DHCD, DBFR 2009 Code Change Process

May 13, 2009 Workgroup 4 (USBC/International Residential Code - IRC) Meeting Agenda Package

NEW ISSUES/PROPOSALS

1. E4002.14 – Tamper-resistant receptacles (**Page 45**)
2. R602.10 – Wall bracing scope (**Page 53**)

FIGURE AO101.1(1)
GRAY WATER RECYCLING SYSTEM FOR FLUSHING WATER CLOSETS AND URINALS

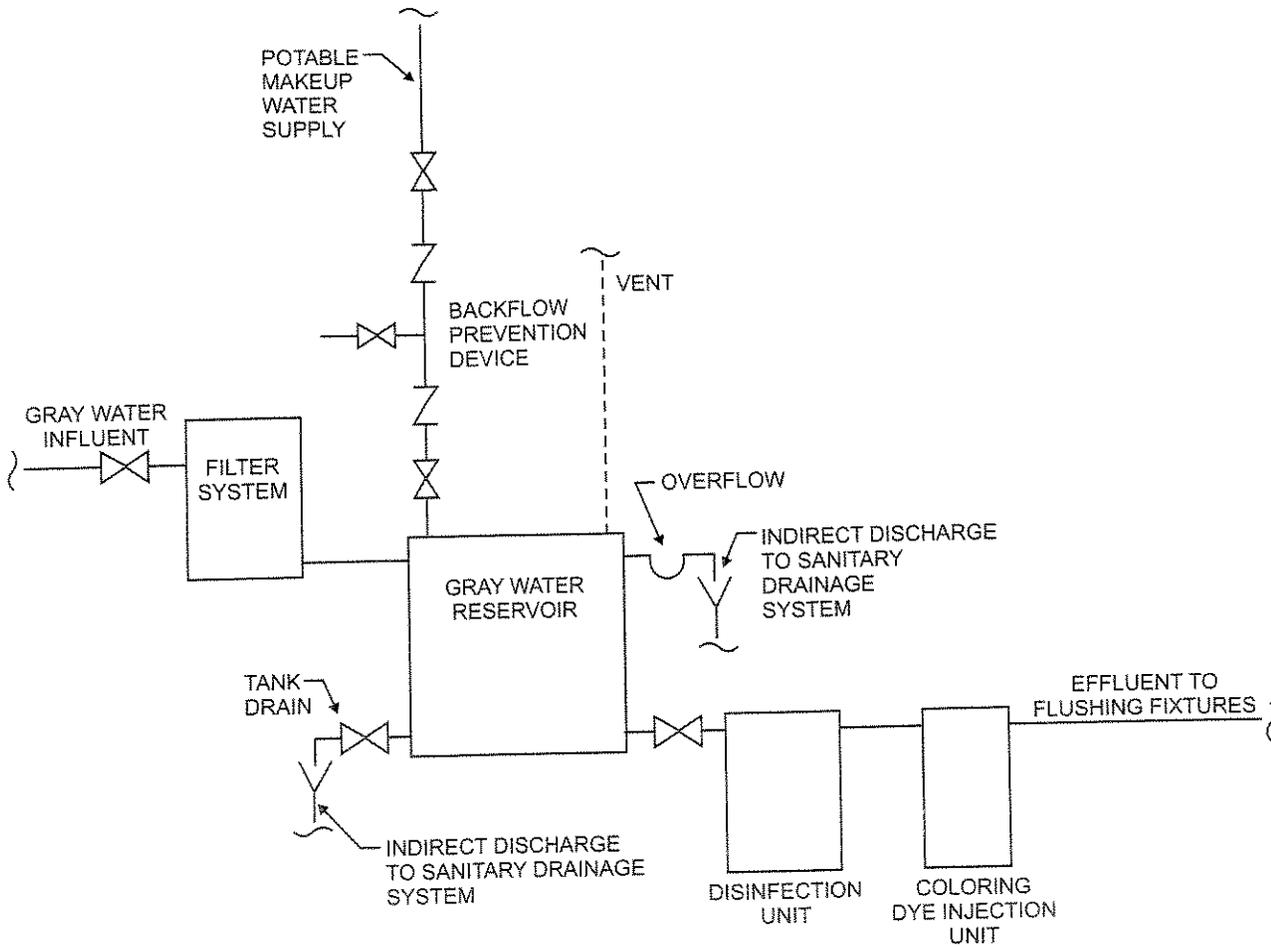
AO102.1 Collection reservoir. The holding capacity of the reservoir shall be a minimum of twice the volume of water required to meet the daily flushing requirements of the fixtures supplied with gray water, but not less than 50 gallons (189 L). The reservoir shall be sized to limit the retention time of gray water to a maximum of 72 hours.

AO102.2 Disinfection. Gray water shall be disinfected by an approved method that uses one or more disinfectants such as chlorine, iodine or ozone that are recommended for use with the pipes, fittings and equipment by the manufacturer of the pipes, fittings and equipment.

FIGURE AO101.1(2)
GRAY WATER RECYCLING SYSTEM FOR SUBSURFACE LANDSCAPE IRRIGATION

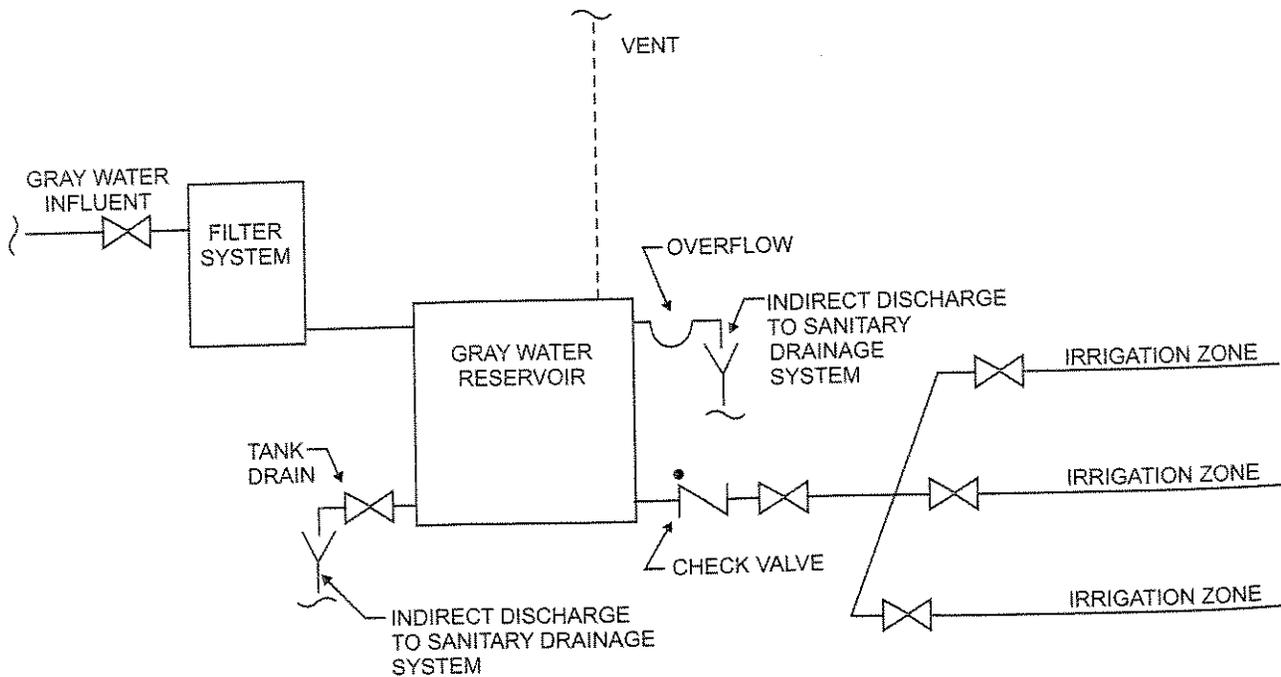
AO102.3 Makeup water. Potable water shall be supplied as a source of makeup water for the gray water system. The potable water supply shall be protected against backflow in accordance with Section P2902 of the *International Residential Code*. A full-open valve shall be located on the makeup water supply line to the collection reservoir.

**FIGURE R602.10.1.1
BRACED WALL LINES**

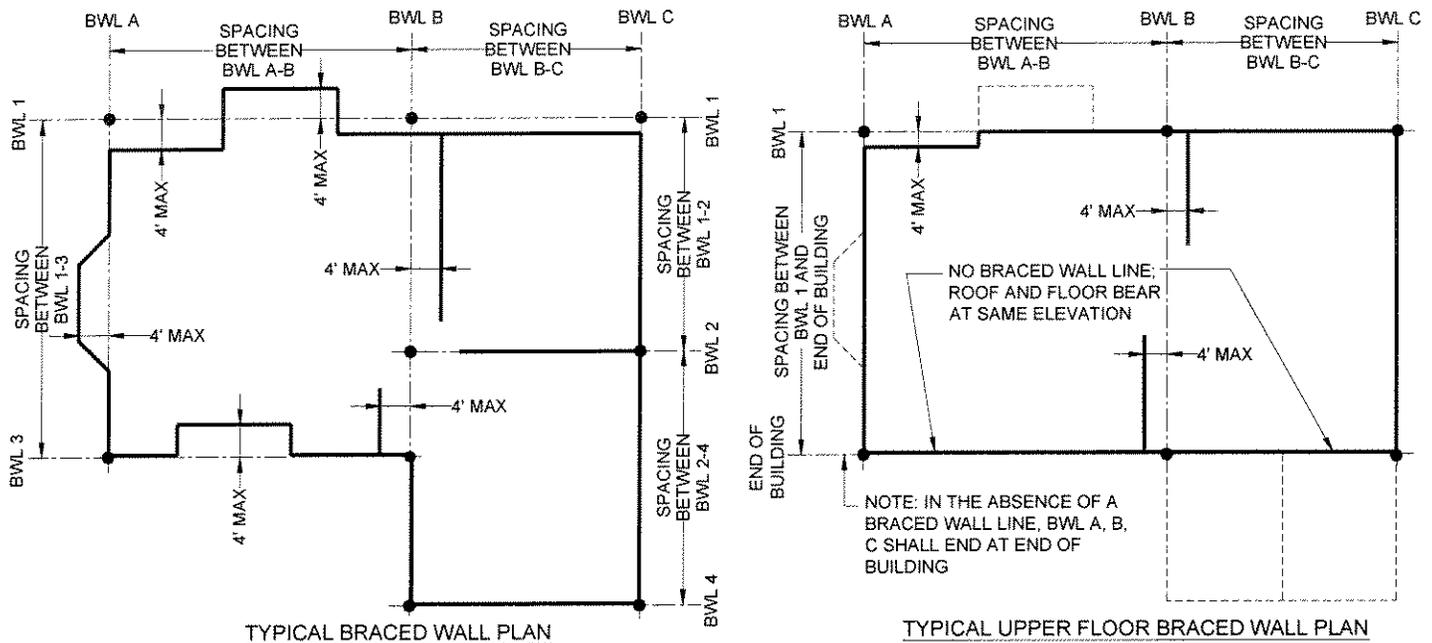
6. Delete Section R602.10 and replace with the following:

R602.10.1.1 Length of a braced wall line. The length of a braced wall line shall be the distance between its ends. The end of a braced wall line shall be the intersection with a perpendicular braced wall line or an angled braced wall line as permitted in Section R602.10.1.4. In the absence of an intersecting braced wall line, the end shall be the farthest exterior wall of the building as shown in Figure R602.10.1.1.

**FIGURE R602.10.1.4
ANGLED WALLS**

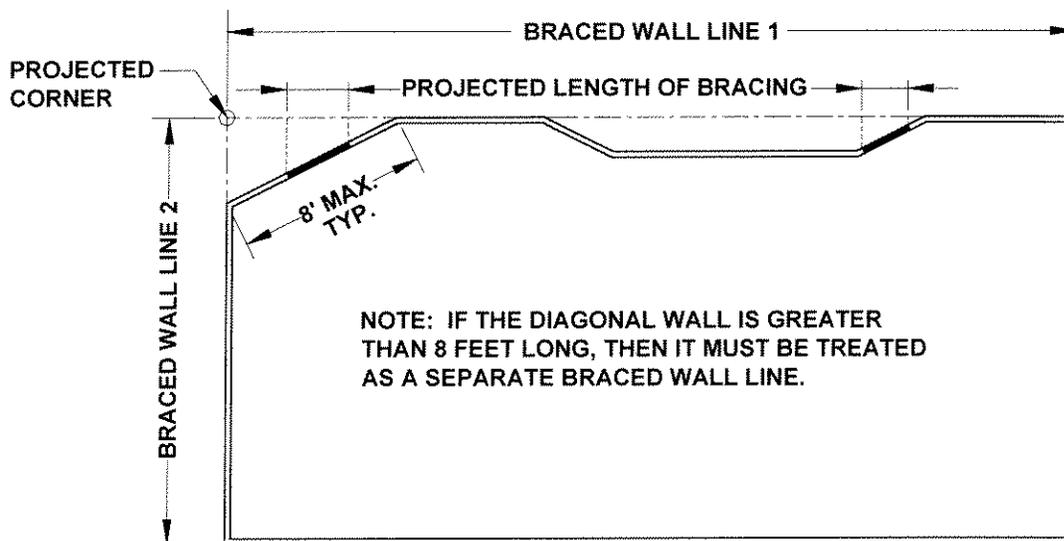
R602.10.1.4 Angled walls. Any portion of a wall along a braced wall line shall be permitted to angle out of plane for a maximum diagonal length of 8 feet (2438 mm). Where the angled wall occurs at a corner, the length of the braced wall line shall be measured from the projected corner as shown in Figure R602.10.1.4. Where the diagonal length is greater than 8 feet (2438 mm), it shall be considered a separate braced wall line and shall be braced in accordance with Section R602.10.1.

**FIGURE R602.10.2.2
LOCATION OF BRACED WALL PANELS**

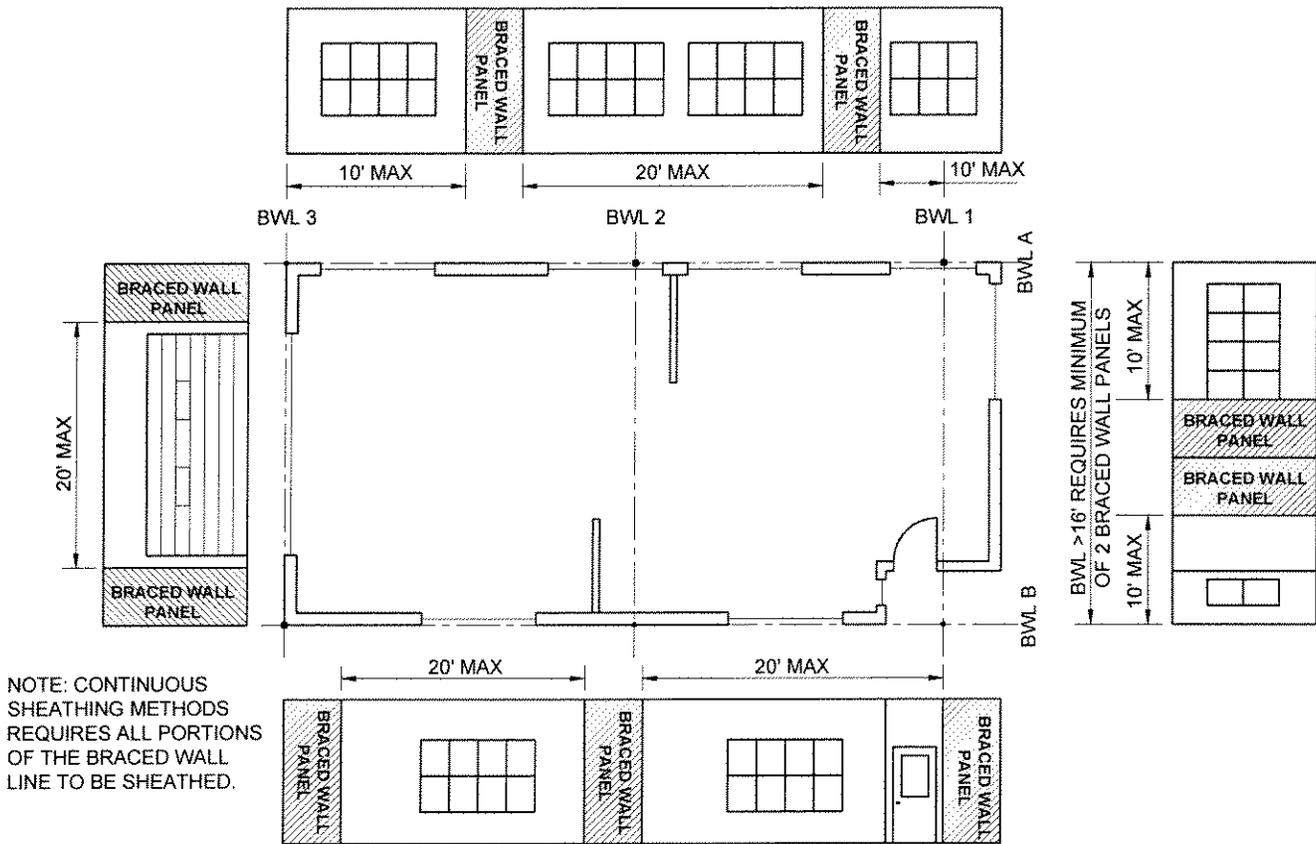
R602.10.2.2 Locations of braced wall panels. Braced wall panels shall begin within 10 feet (3810 mm) from each end of a braced wall line as determined in Section R602.10.1.1. Braced wall panels shall be located within 20 feet (6096 mm) from another braced wall panel measured between adjacent edges as shown in Figure R602.10.2.2.
